NORTHAMPTON
GATEWAY
STRATEGIC RAIL FREIGHT INTERCHANGE

PARAMETERS PLAN – MINOR AMENDMENTS

DOCUMENT 8.15

PARAMETERS PLAN – MINOR AMENDMENTS | 26 FEBRUARY 2019

Appendix 1
Revised Parameters Plan

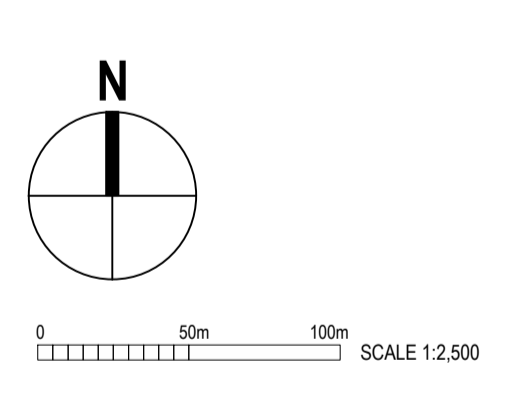
Plan. A minor amendment to the Parameters Plan to move the position of the rail corridor, and the corridor for the rail tunnel, slightly to the north, at the northern rail access location, would be required to accommodate this potential rail alignment.

- 3.4 An amendment to the Parameters Plan is therefore proposed. The amendment removes the 'Parameters Note' text cross referring to landscape cross section and inserts fixed bund heights at given positions along all the strategic landscape screen bunds. The key on the plan identifies the spot heights. It also confirms that the height of the bund between two consecutive spot heights will be no lower than the lower of the two spot heights and no higher than the higher of the two spot heights. The parameters set therefore provide a great deal of certainty as to the heights of the strategic landscape bund along their whole length. The heights that are set accord with the heights shown on the landscape cross sections and therefore accord with what has been assessed within the Environmental Statement.

S2 11.02.2019 Rail tunnel corridor re-aligned, top of bund spot heights added 2.10 S2
 Rev Date Details of issue / revision Dwr Rev
ISSUES & REVISIONS
ROXHILL
NORTHAMPTON GATEWAY
 STRATEGIC RAIL FREIGHT INTERCHANGE
THE NORTHAMPTON GATEWAY RAIL FREIGHT INTERCHANGE ORDER 201X
 Drawing Title
PARAMETERS PLAN
 Scale 1:2,500 Drawn RM
 Size A0 Reviewed SH1
 Regulation Document
Reg 5(2)(o) 2.10
 Drawing Status
SUBMISSION
 Drawing No. 4054 - R007 Revision S2

**Key Plan (Document 2.2), Sheet 1 (Document 2.2A) and
Main Site Composite (Document 2.2G)**

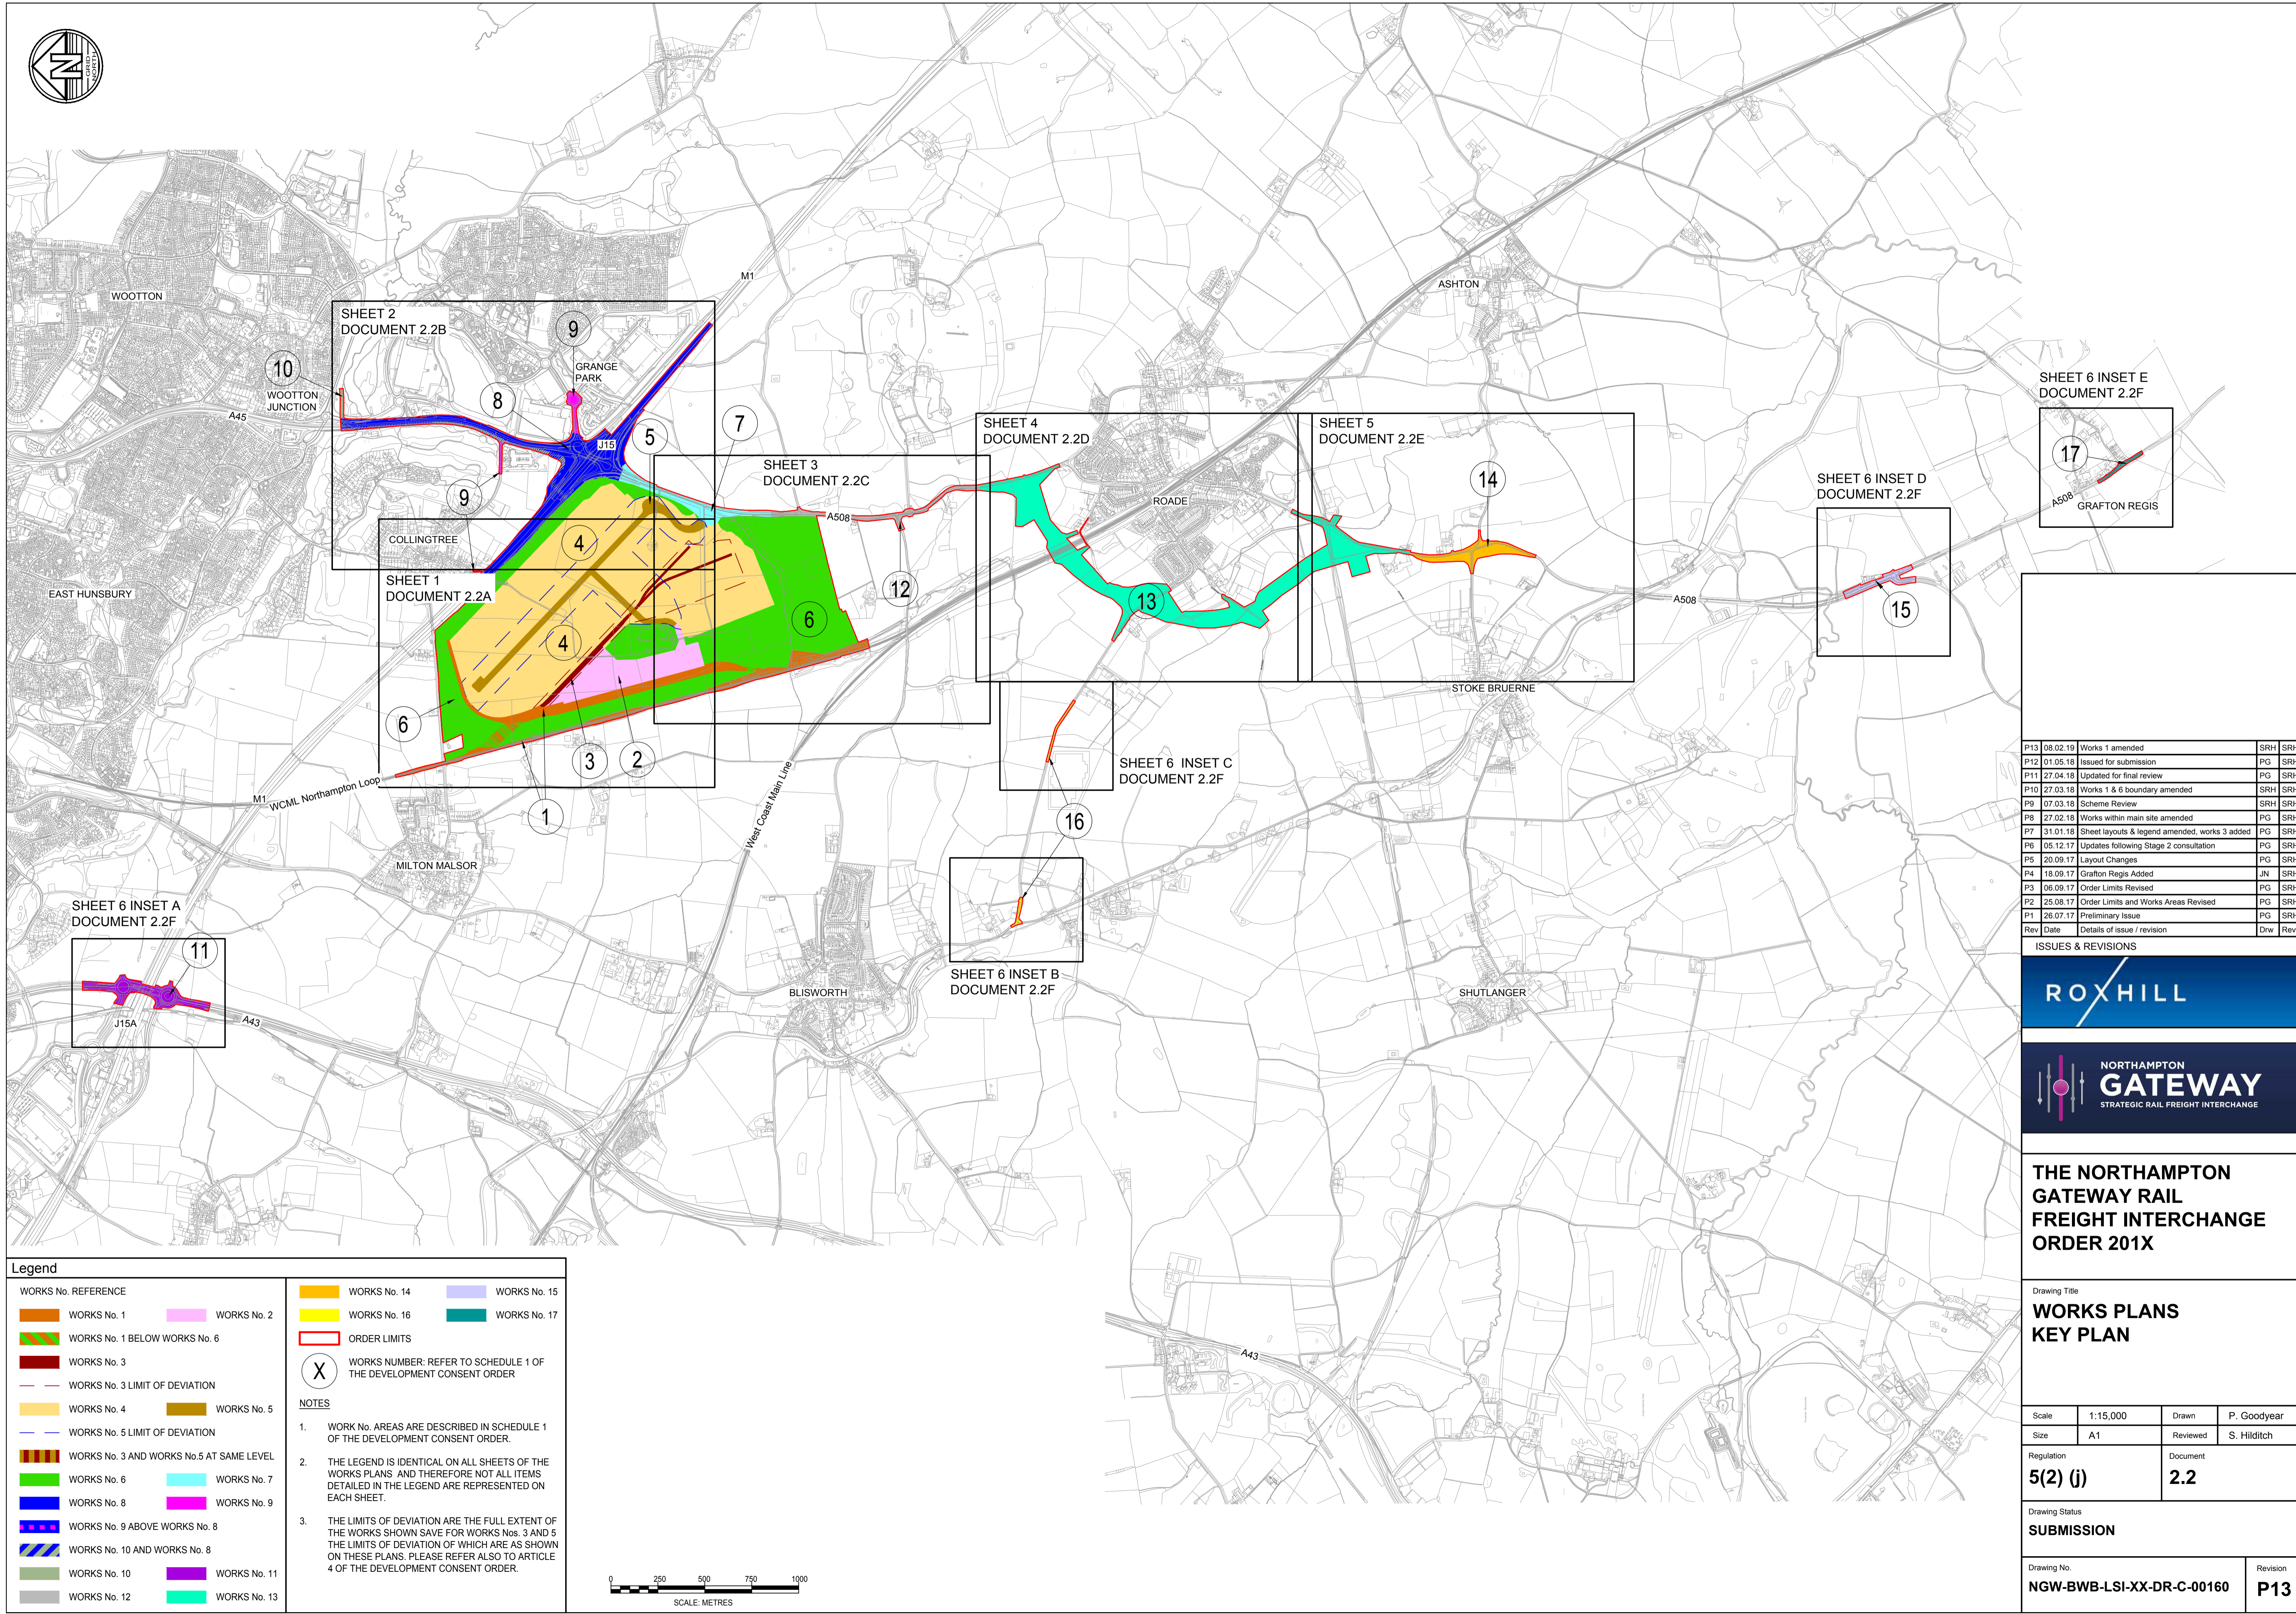
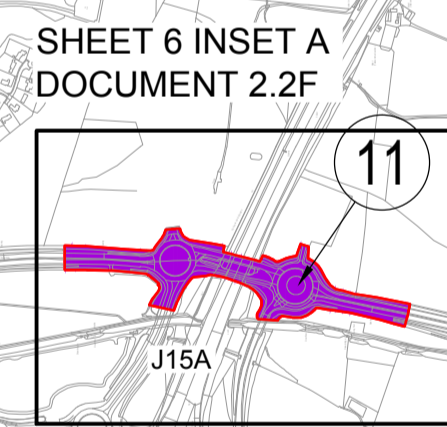
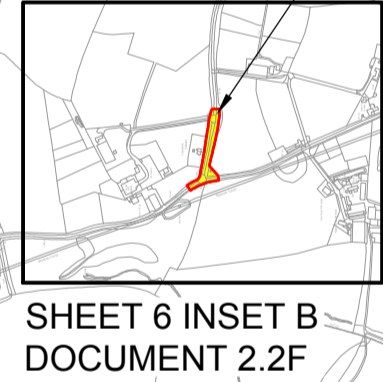
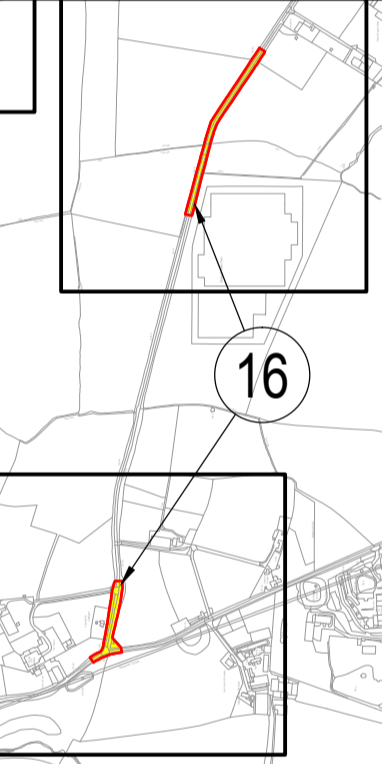
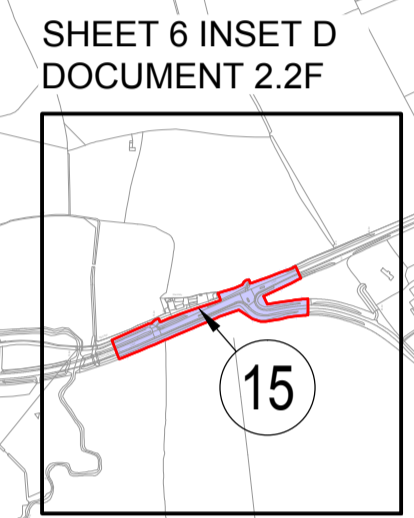
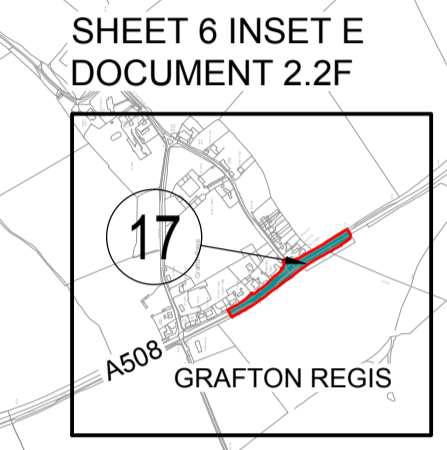
- 4.2 The change to the Parameters Plan relating to the rail access would require a consequential change to the area of Works No.1 , being the Works relating to rail infrastructure and, accordingly, revised Works Plans are also required, as follows:
- Works Plan Key Plan (**Document 2.2** Rev P13)
 - Works Plans Main Site Composite (**Document 2.2G** Rev P5).
 - Works Plans Sheet 1 (**Document 2.2A** Rev P10)
- 4.3 These plans are included in **Appendix 4** and are also submitted as separate documents for certification purposes.

Rev	Date	Details of issue / revision	PG	SRH	Drw	Rev
P13	08.02.19	Works 1 amended	SRH	SRH		
P12	01.05.18	Issued for submission	PG	SRH		
P11	27.04.18	Updated for final review	PG	SRH		
P10	27.03.18	Works 1 & 6 boundary amended	SRH	SRH		
P9	07.03.18	Scheme Review	SRH	SRH		
P8	27.02.18	Works within main site amended	PG	SRH		
P7	31.01.18	Sheet layouts & legend amended, works 3 added	PG	SRH		
P6	05.12.17	Updates following Stage 2 consultation	PG	SRH		
P5	20.09.17	Layout Changes	PG	SRH		
P4	18.09.17	Grafton Regis Added	JN	SRH		
P3	06.09.17	Order Limits Revised	PG	SRH		
P2	25.08.17	Order Limits and Works Areas Revised	PG	SRH		
P1	26.07.17	Preliminary Issue	PG	SRH
